Great Western Highway Upgrade
Blackheath to Little Hartley – EIS Submission
PO Box 334
PARKES NSW 2870

Great Western Highway Upgrade: Blackheath to Little Hartley EIS (SSI-22004371)

Proximity of Greaves Creek Catchment to Blackheath portal and construction zone. SIX Maps, NSW Govt.

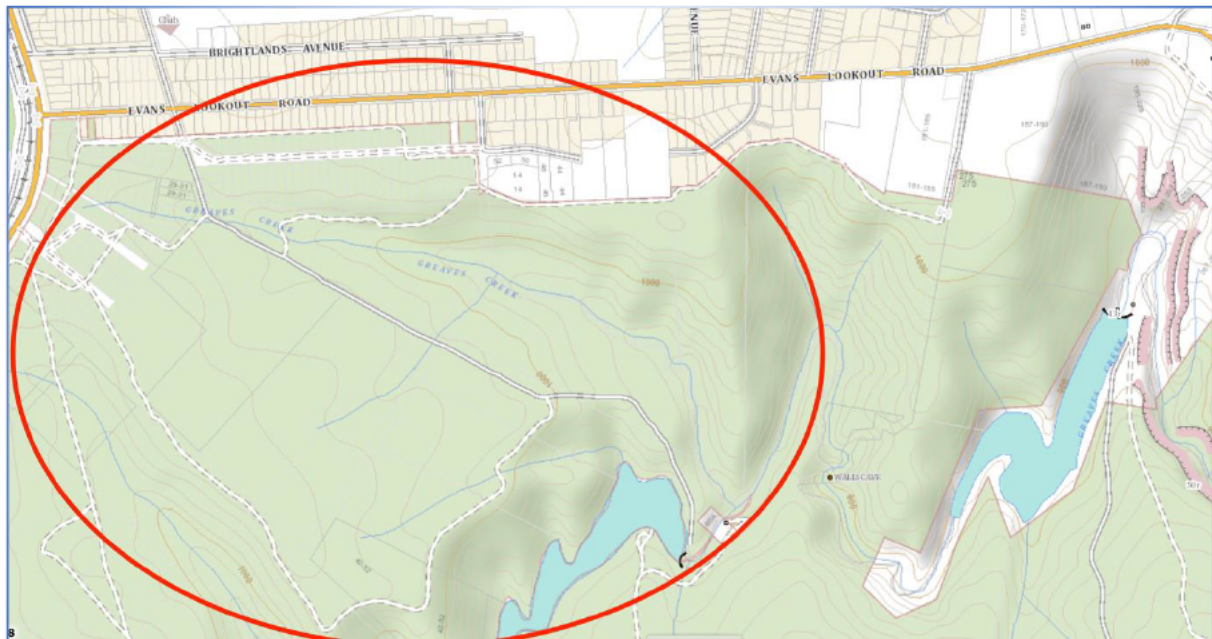
Of great concern is the Greaves Creek system due to its proximity to the Blackheath portal (see map below). The Greaves Creek system comprises THPSS that contain confirmed populations of Giant Dragonfly (*Petalura gigantea*) and Blue Mountains Water Skink (*Eulamprus leuraensis*), both endangered groundwater-dependant species.

The map highlights the proximity of the Greaves Creek system to the highway corridor and clearly shows that the headwaters of this system are within the middle of the proposed Blackheath construction site. This area on the east of the GWH is also a designated Sydney Water Special Area. The *Blue Mountains Special Areas: Blackheath, Katoomba* are protected because they collect drinking water for the neighbouring Blue Mountains urban populations. According to WaterNSW's Facts Sheet, "Special Areas are large areas of mostly unspoilt bushland surrounding the reservoirs that provide drinking water for Sydney, the Blue Mountains and the Illawarra. Special Areas are vital to the protection of our drinking water because they help filter out unsafe nutrients and other substances before the water reaches the reservoirs." Because of this role the public is not allowed in these areas. This calls for extra effort to ensure drinking water is not being impacted. [See map at www.watarnsw.com.au/water-services/water-storage/managing-dams-and-reservoirs]
